## Eliminating Symptoms - Engine: Replacing Intake Manifold Pressure Sensor (Vehicle jerking while driving/SY2314)

Vehicle Type: **918 Spyder**

Subject: **Intake manifold pressure sensor**

Figure 1

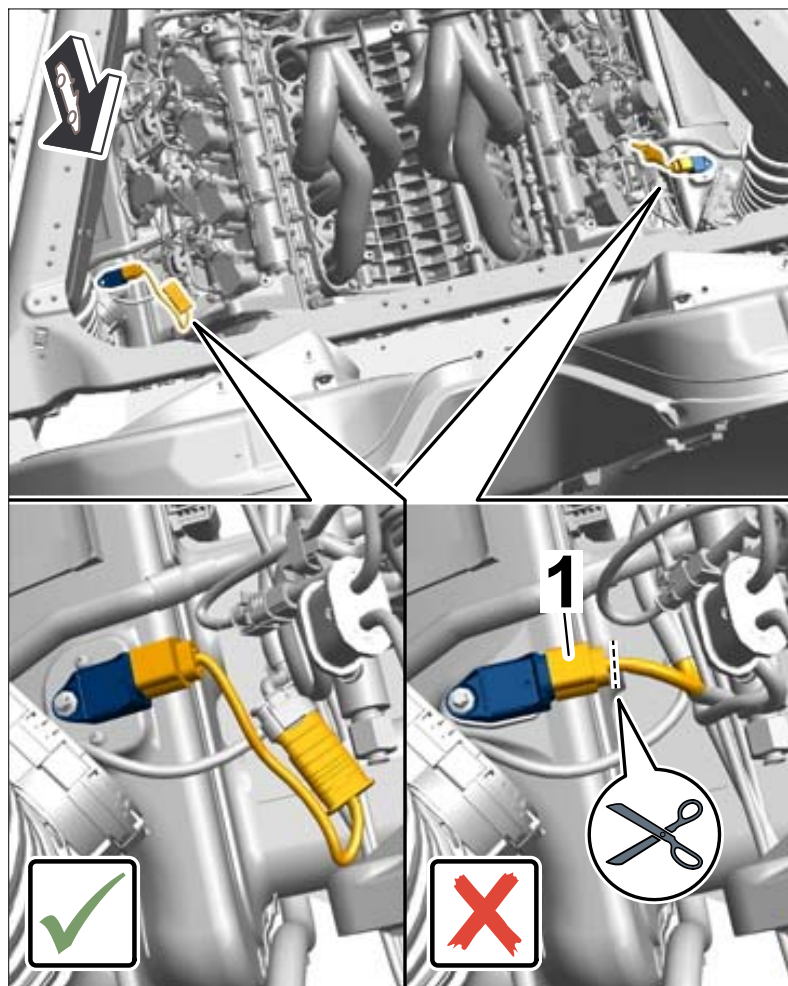
- 2.1 If the **adapter intermediate piece is already fitted** between the engine wire harness and intake manifold pressure sensor connector (⇒ *Figure 1-Left-*)

- 2.2 If there is **no adapter intermediate piece** between the engine wire harness and intake manifold pressure sensor connector (⇒ *Figure 1-Right-*)  
The engine wire harness connector (⇒ *Figure 1-Posi. 1-*) is secured directly to the intake manifold pressure sensor connector.

⇒ **The engine wire harness connector must be reworked:**

⇒ Replace the **existing adapter intermediate pieces with the adapter cables** (variant a – Part No.: 918.607.105.00 – Adapter with cable – 2 required) **and replace the intake manifold pressure sensors.**

- 2.2.1 Disconnect engine wire harness connector from the cable (⇒ *Figure 1 - Use wire cutters - Pos. 1-*) and crimp the new connector with new contacts and single-wire seals (variant b – Part No. of set: 918.607.913.00 – 2 required) to the engine wire harness.
- 2.2.2 Repeat Step ⇒ 2.2.1 on the other cylinder bank.
- 3 Install exhaust system, see Workshop Manual ⇒ *Workshop Manual '260119 Removing and installing exhaust system'*, section on "Installing exhaust system" and "Subsequent work".
